TECHNICAL MEMORANDUM

**Re: Phase 3 RI Modification No. 15
Supplemental Soil Gas Investigation in Operable Unit 3
Nevada Environmental Response Trust Site
Henderson, Nevada
Ramboll Project No. 1690025040-046**

This Technical Memorandum presents Ramboll US Consulting, Inc.'s (Ramboll's) recommended Modification No. 15 to the scope of work for Phase 3 of the Remedial Investigation (RI) currently in progress at the Nevada Environmental Response Trust ("NERT") Site (the "Site") located in Henderson, Nevada. On June 29, 2022, the Nevada Division of Environmental Protection (NDEP) provided comments to the *Baseline Health Risk Assessment Work Plan for OU-3* (February 28, 2022). Per Attachment A, General Comment No. 1 of the NDEP comment letter, NDEP indicated that the existing soil gas data for chloroform in the OU-3 area west of Pabco Road and north of Galleria Drive may not be adequate to assess risk and may not represent a worst case or Reasonable Maximum Exposure (RME) condition. NDEP has suggested that a supplemental soil gas investigation be conducted in this area. The Phase 3 RI Modification No. 15 was prepared such that this data can also be incorporated into the Remedial Invest

Figure
1

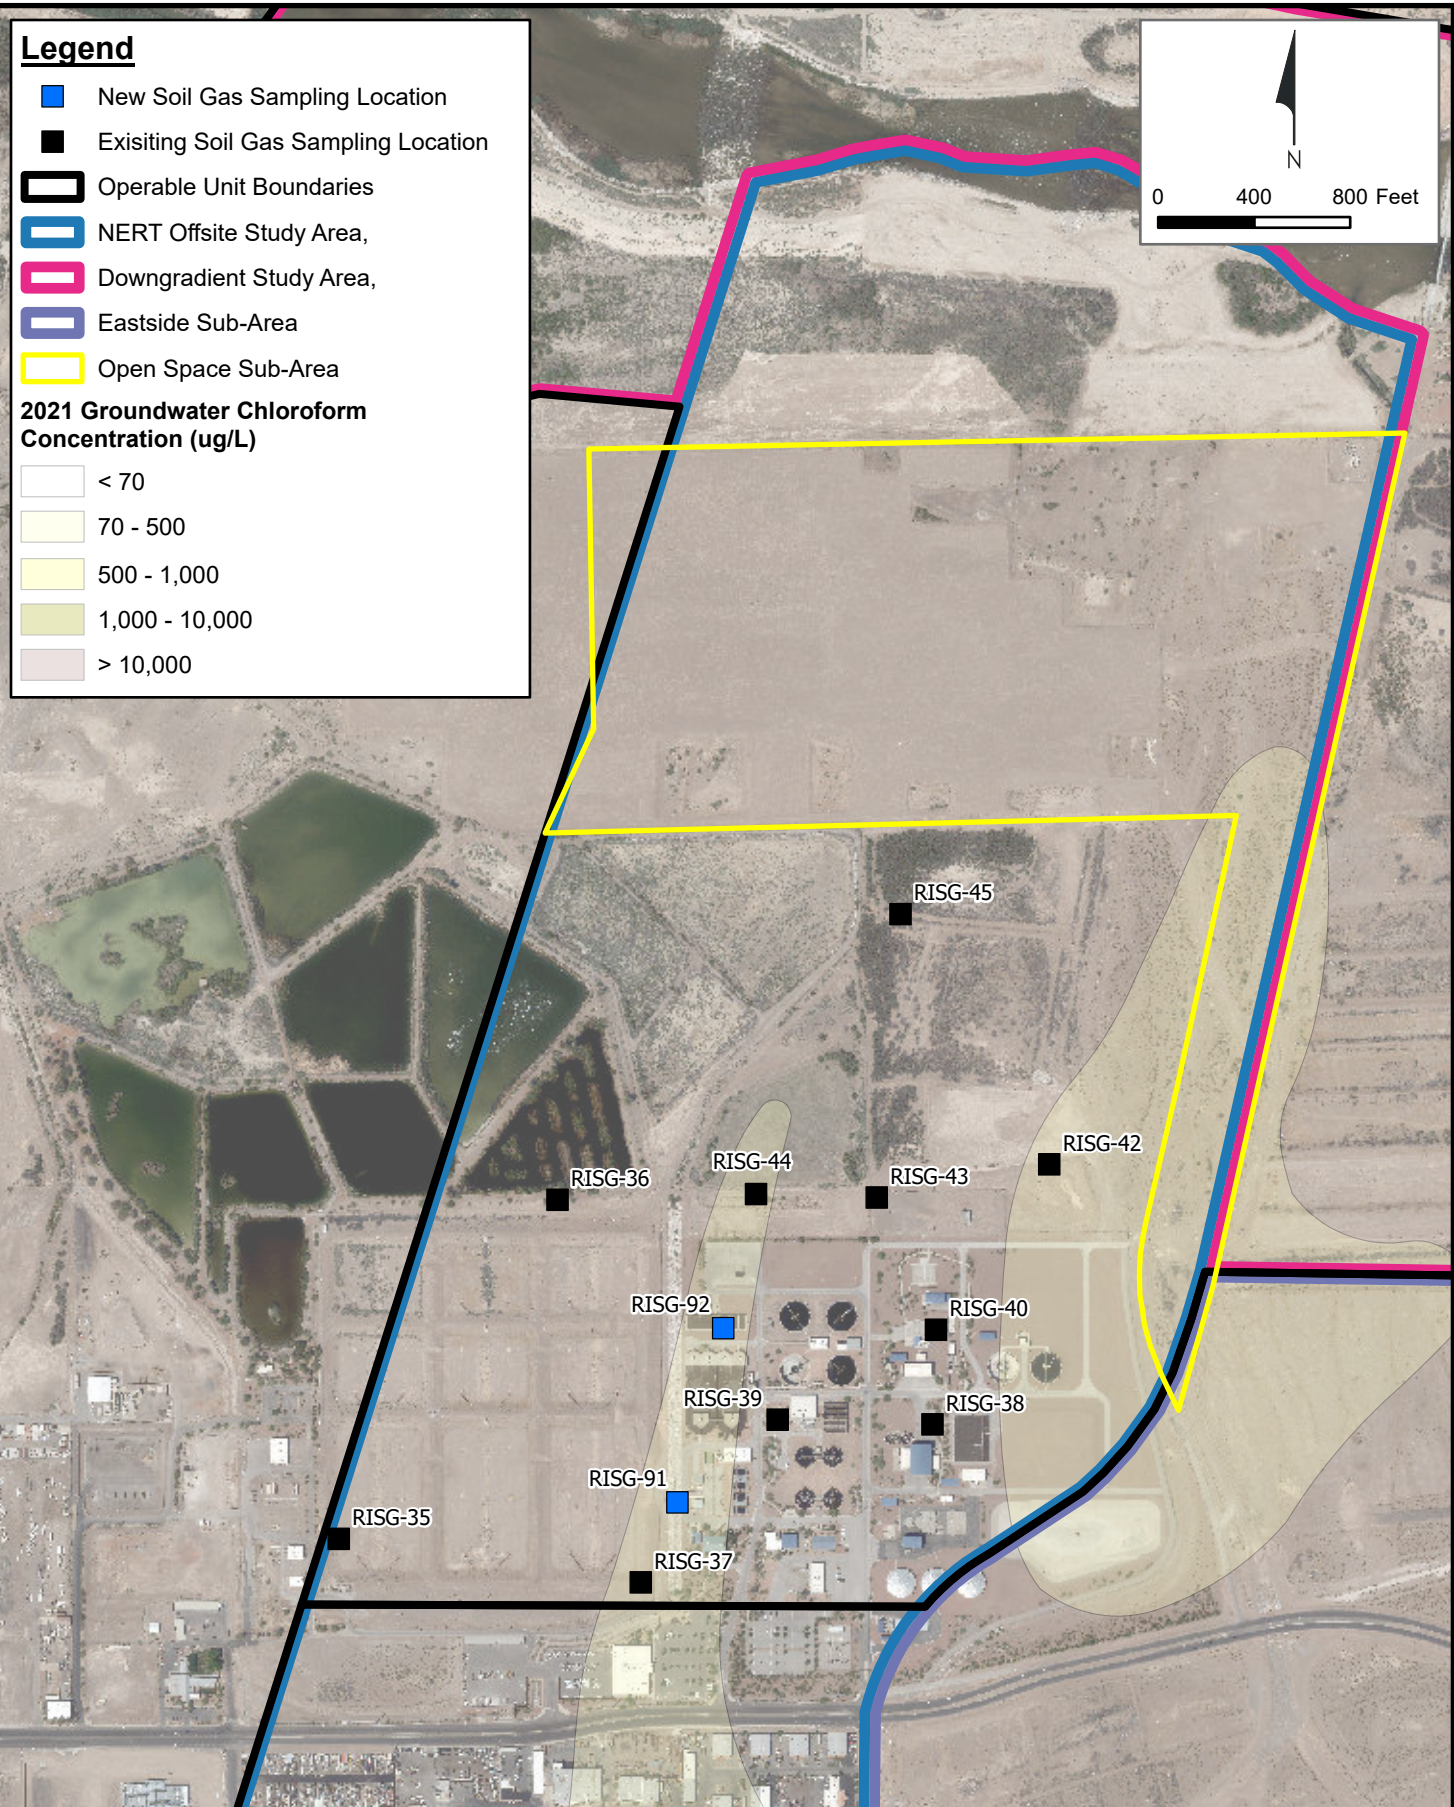
Assessment Work Plan for OU-3, NERT is not proposing any additional soil gas sampling associated with the eastern plume since it is not associated with contamination migrating in groundwater from OU-1. Accordingly, NERT is proposing to install two multi-level soil gas probe locations (RISG-91 and RISG-92) as shown on Figure 1. Multi-level soil gas probes will be installed at each location, with one probe installed to a depth of 5 feet below ground surface (bgs) and one probe installed to 15 feet bgs. The proposed sample locations and depths may be adjusted in the field based on utility clearances, access constraints, drilling refusal, or depth to groundwater; however, all will be located outside of the BRC Open Space Sub-Area. Based on the soil gas investigation conducted in this area under Phase 3 RI Modification No. 7, refusal (likely due to caliche) or a shallow depth to water has previously been encountered and may require modification of the depth of the deeper soil gas probes. A deeper probe will not be installed at a given location at a depth that is less than 10 feet bgs.

Soil gas samples will be collected at the two new multi-level probe locations described above and at 10 existing locations (RISG-35, RISG-36, RISG-37, RISG-38, RISG-39, RISG-40, RISG-42, RISG-43, RISG-44, and RISG-45) that were previously installed as part of Phase 3 RI Modification 7 and are outside of the BRC Open Space Sub-Area (also shown on Figure 1). Existing soil gas sampling locations RISG-41 and RISG-46 are located within the Open Space Sub-Area, and therefore will not be resampled. Table 1 provides a summary of the anticipated soil gas samples to be collected at the new and previously existing soil gas probes. In all, up to 22 investigative soil gas samples may be collected.
